City of West Linn PRE-APPLICATION CONFERENCE MEETING Notes

2 year Extension of previous approval for subdivision at 22910

Weatherhill Road

Project #: **PA-10-20**

> TENTATIVE PRELIMINARY SITE PLAN

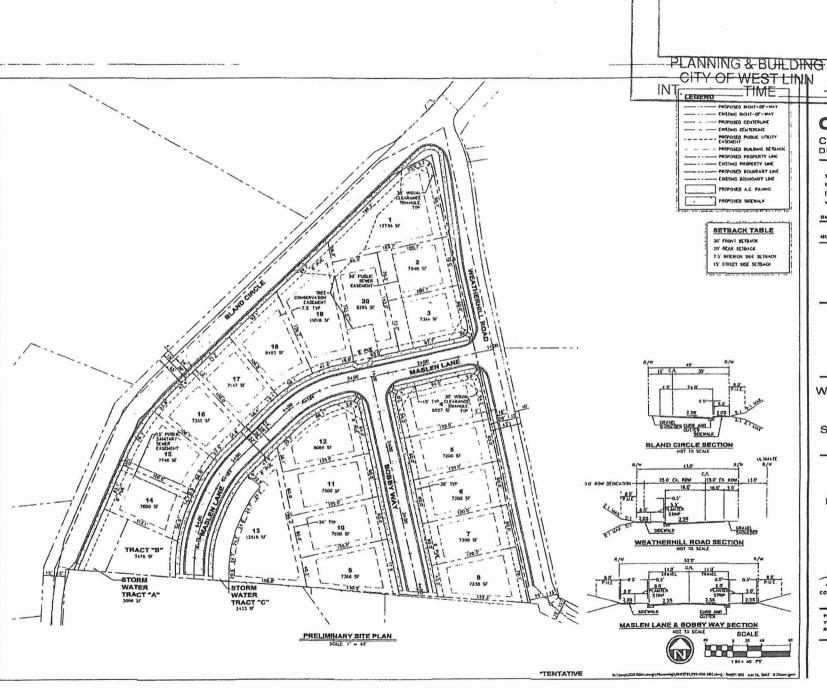
All sidewalks must have the same width of 6' wide.

New water line along the project frontage on Bland Circle shall be 10" DI pipe.

Provide street lights.
